SERVICE LETTER 127

Nose Gear End Cap Cracks

Aircraft Makes/Model(s):	Float Model(s):	Compliance: Mandatory	By: MAS
Multiple	6100A, 7000A, 8000A, 8750A	Part Number: 1005732	Approved: DRH
		Date: 5/15/2024	Revision: C

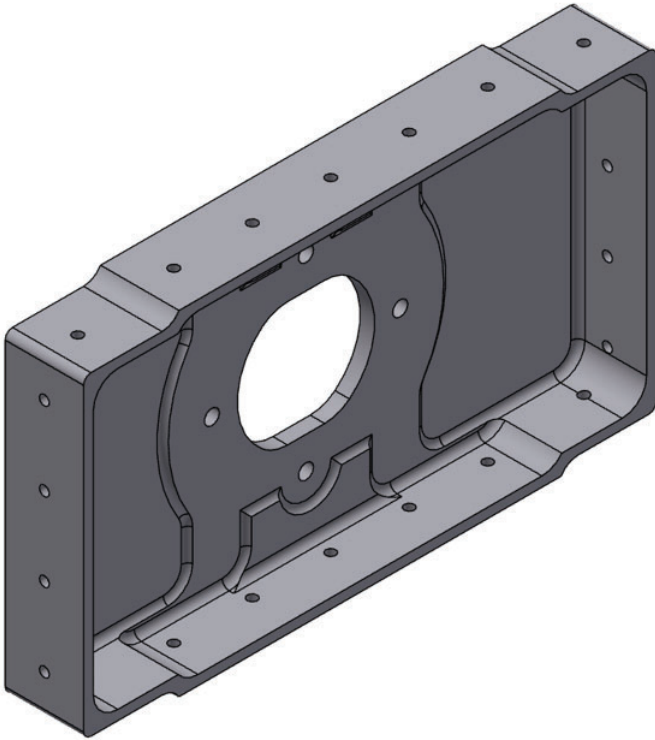
Several Nose Gear Box End Caps have been found to have cracks propagating from around the Cylinder Mounting Flange bolts (4). If these cracks go undetected there is a possibility that the End Cap can break, letting the actuator cylinder move to the selected gear position, and the gear position lights indicate that the selected gear position has been reached when it has not.

**LATER REVISION
EXAMPLE WITH RAISED
MACHINE SURFACES**

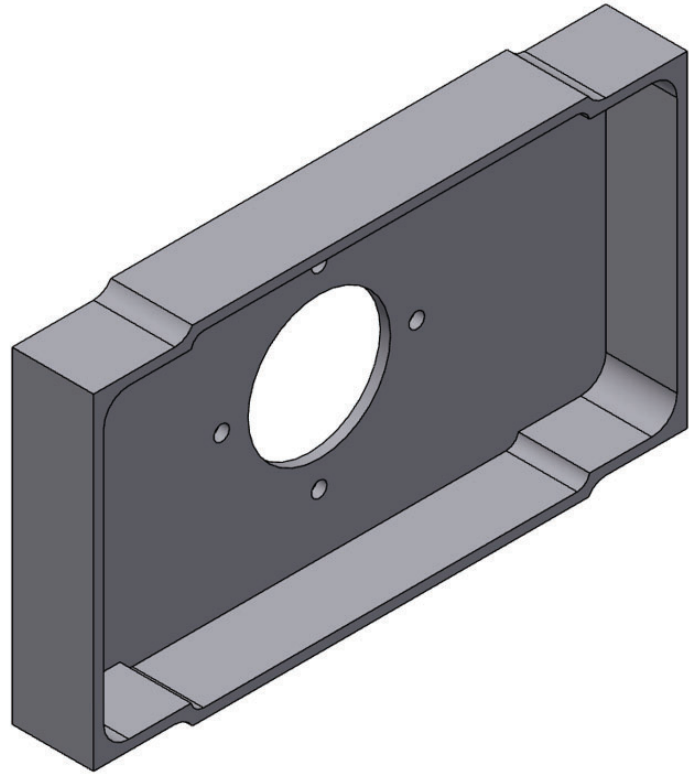
A close visual inspection must be accomplished within the next 25 hours of operation, and every 50 hours thereafter. The cracks will be best visible by looking at the forward face of the End Cap, through the forward open end of the Nose Gear Box. It appears that the cracks start just above the top mounting bolt and just below the bottom mounting bolt as shown in Figure 1. If cracks are found, the End Cap Part, #8A07201-002 or part number 6A07210-001, must be replaced. After inspection and/or replacement, re-adjust the gear "down" over-center lock, so that it hits the end of the lock-up track, and has little to no preload pressure on it since the preload pressure would cause extra stress at the Cylinder Mounting Flange and the End Cap. Replacement of the older revision parts with later revision parts will eliminate the requirement for 50 hour internal inspections, but this inspection should still be accomplished at 100 hour intervals thereafter. Later revision parts will be made easily distinguishable by their raised flats to the top and bottom of the fitting at the attachment bolt areas as shown below.

Figure 1

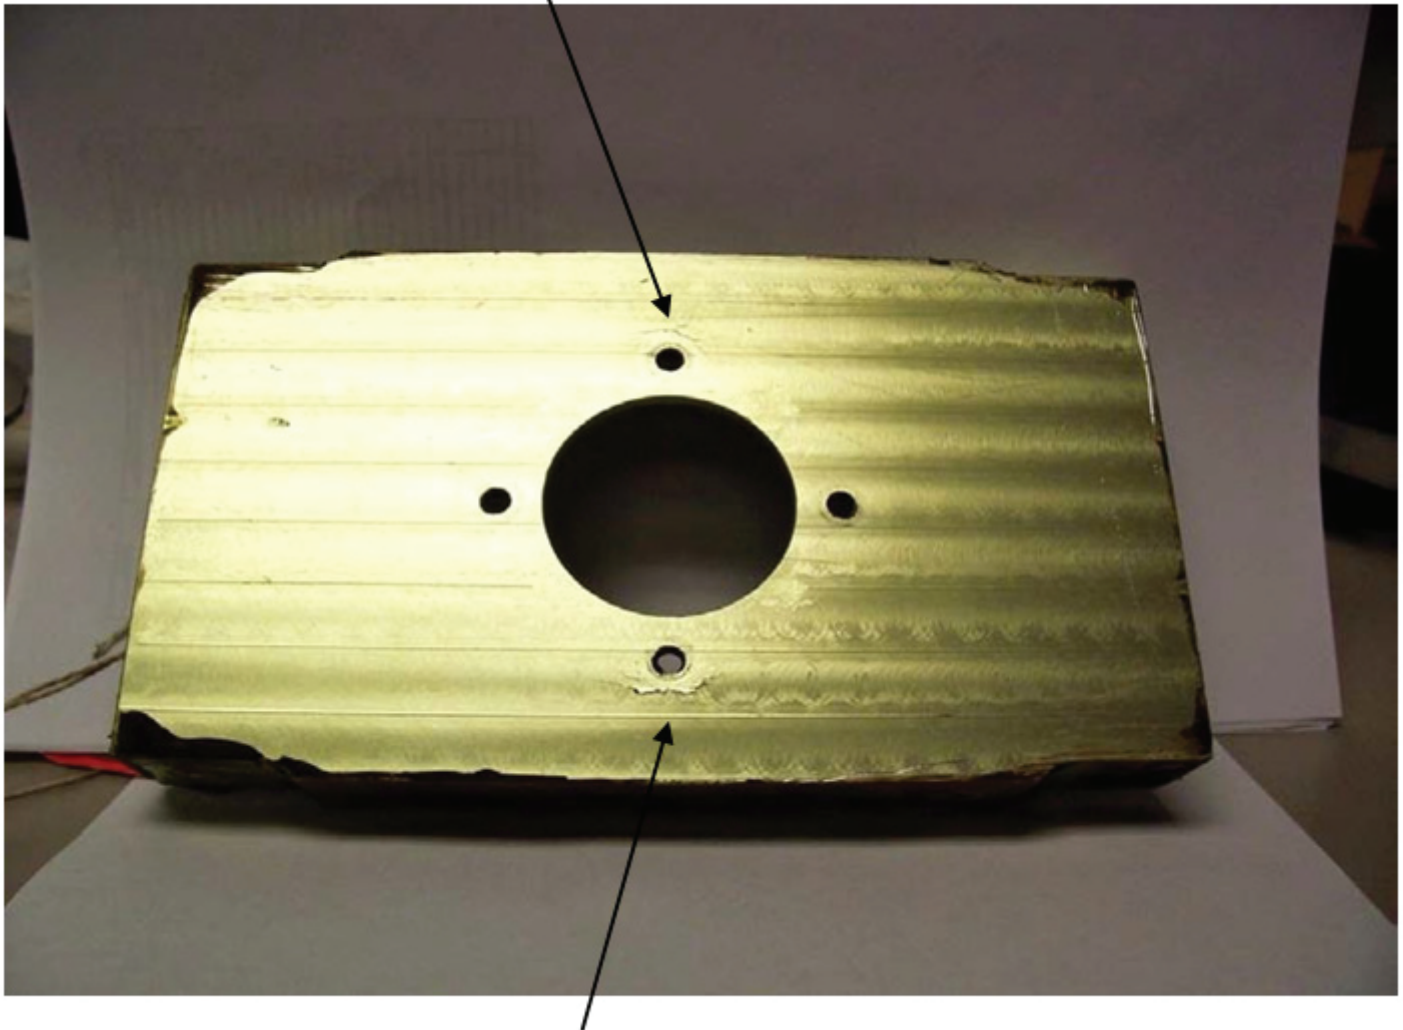
Notes: The following (figure 1) shows part that is cracked and (figure 2) item (1) shows its location on the nose box assembly. This is the forward side of the part which can be seen looking into the open (front) end of the nose gear box. No disassembly should be required to examine this area. The area should be thoroughly cleaned before inspecting. Use good lighting. If in doubt, dye penetrant inspection can also be accomplished.

Visible Crack

Visible crack

If evidence of cracking is found in Nose Box End Cap, either by visual or dye penetrant inspection per figure 1, the following instructions will be accomplished to replace damaged Nose Box End Cap:
